**Attachment 2 to PLA-6242**  
**Non-Proprietary Version of the Request for**  
**Additional Information Responses**

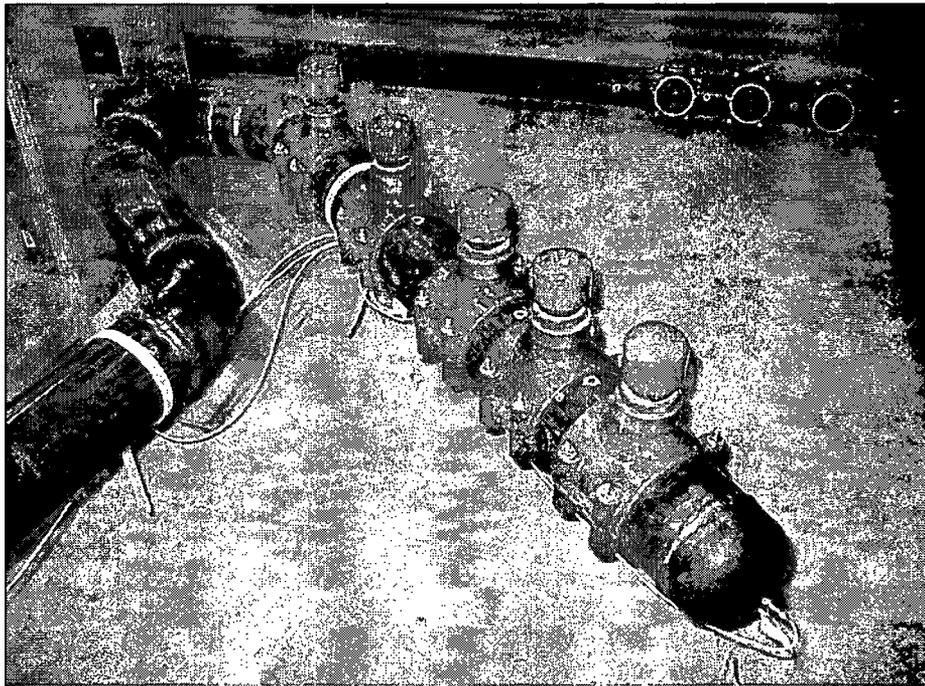
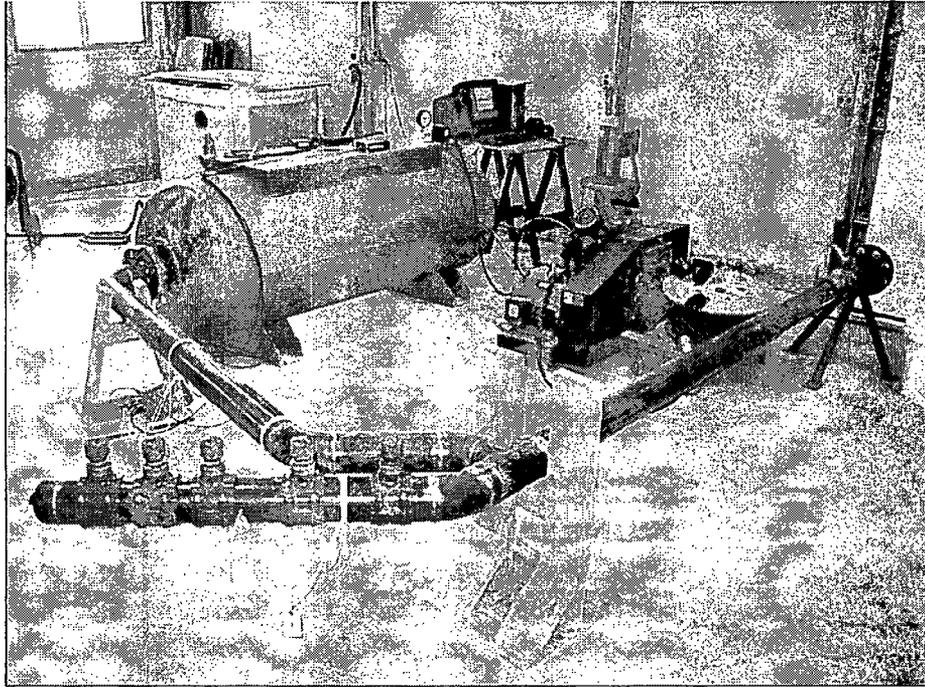
- (c) In its response to RAI 4 (and RAI 31), PPL supplied more details on the MSL geometry. It seems that the lower strain gauges on steam lines A and D are very close to (1) the T-junction at the mouth of the dead leg and (2) to a pressure node of the 16 Hz component. Concerning Item (1), PPL is requested to explain how it accounts for the effect of the pipe stiffening (being close to a T-junction) when relating the pipe strains to acoustic pressure. Regarding Item 2, the lower strain gauges on Lines A and D are nearly "blind" to the 16 Hz component, which is the

strongest dynamic loading on the dryer. Since PPL is planning to use MSL measurements to evaluate the dryer stresses for the last two steps of power ascension to EPU of Unit 1, the measurement accuracy and uncertainties of the lower strain gauges should be re-assessed. First, the lower strain gauges are blind to the 16 Hz component and they are also close to the T-junction, which influences the conversion factor. PPL is requested to explain whether the lower strain gauges will be repositioned (away from the pressure node) or if additional strain gauges will be installed on lines A and D (i.e., use a 3-location measurement method for MSL pressures).

- (c) There are no plans to reposition or install additional MSL strain gauges.

]] In addition, when the strain gauges were installed, ultrasonic measurements were taken at their locations to determine the actual pipe thickness. These thickness measurements were used in the determination of the micro-strain to pressure conversion factors.

During the Unit 1 power ascension to 107% CLTP, data will be concurrently recorded from the dryer instrumentation, and main steam line strain gauges. This data will be used to assess the uncertainties associated with the entire suit of steam line strain gauge readings. If this review indicates that the relocation of the main steam line strain gauges is warranted, this action will be accomplished prior to increasing power above 107% CLTP.

**FIGURE 2-1 - Photographs Of Susquehanna Blowdown Facility:  
Entire Scaled Main Steam Lines A & D (Top); and  
Deadheaded Branch Line (Bottom)**

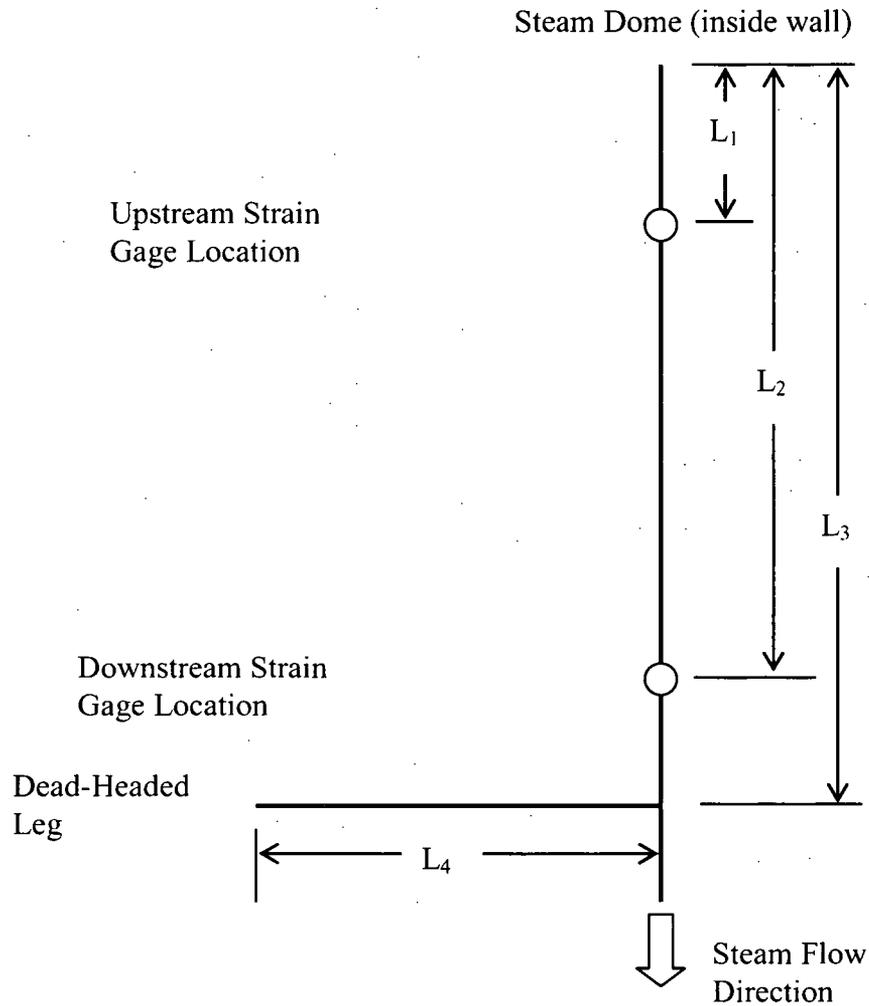
- (b) PPL also refers to the turbulent eddies at the inlets of MSLs as the excitation source of the low frequency components (16 and 32 Hz). While this is a plausible excitation source, PPL neglects the possibility of flow excitation at the mouth of the dead leg. Simple calculations based on  $f=16$  Hertz (Hz),  $V = 153$  fps, and 24" diameter pipe, gives a Strouhal number of about 0.21. This is close to the critical value for this geometry (see Figs. 12 & 13 of paper by Peters & Bokhorst 2000, "Flow-excited pulsations in pipe systems with closed branches, impact of flow direction," in Flow-Induced Vibration, Balkema 2000). However, the geometry of the T-junction edge is crucial. PPL is requested to (1) evaluate this possible excitation source; (2) provide information on the geometry of the T-junction edge (sharp or rounded and at what radius); and (3) explain whether the geometrical details of the T-junction edges and the length of MSL A were properly modeled in the SMT study.

(b)(3) The one-sixth scale model was fabricated as near as practical to full scale. See the response for RAI 2(b)(2) above.
